## Product Change Notification / JAON-17DZYV010

CCB 4560 Initial Notice: Qualification of SIGN as a new assembly site for selected SST39LF80xx, SST39VF160xx and SST39VF80xx device families available in 48L TSOP (12x20mm) package.

**CCB 4560**  
**Pre and Post Change Summary**  
**PCN # JAON-17DZYV010**

# Lead frame Comparison

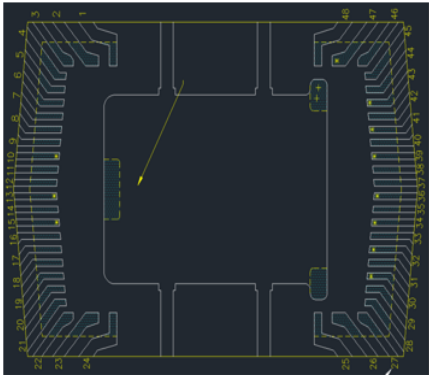
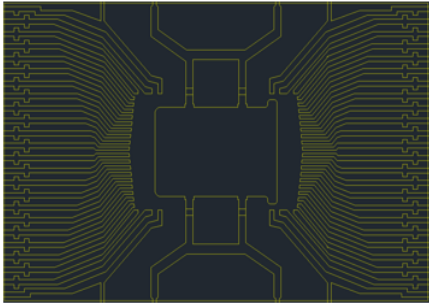
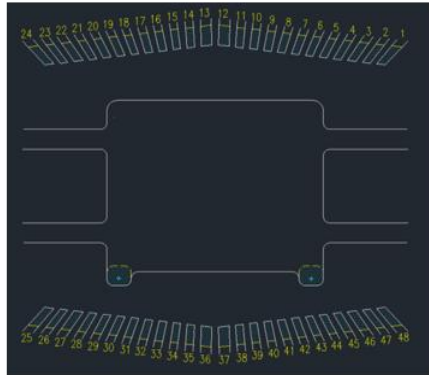
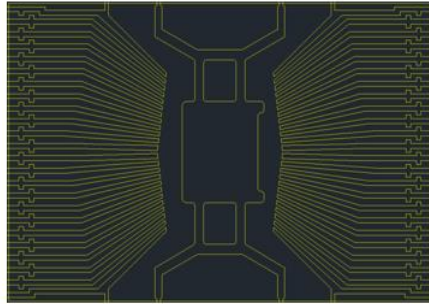
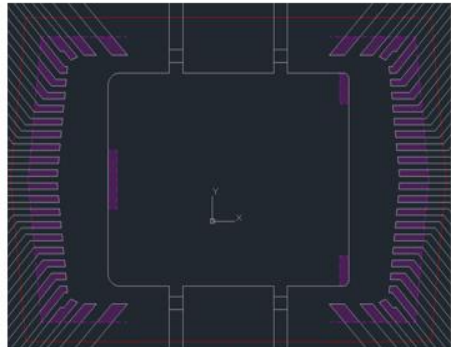
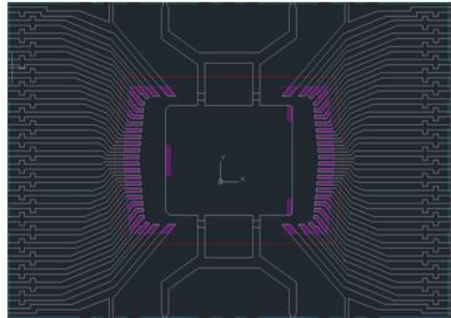
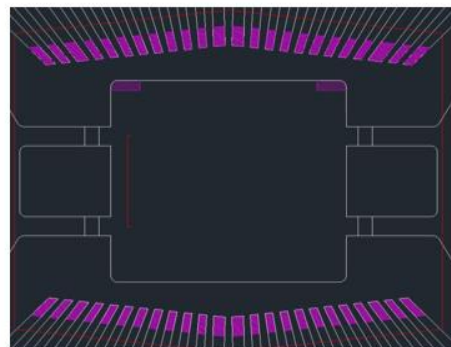
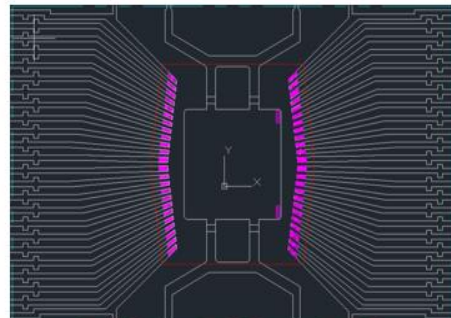
Pre Change LPI		Post Change SIGN	
Applicable for SST39VF160xx device family.	Applicable for SST39LF80xx and SST39VF80xx device families	Applicable for SST39VF160xx device family.	Applicable for SST39LF80xx and SST39VF80xx device families
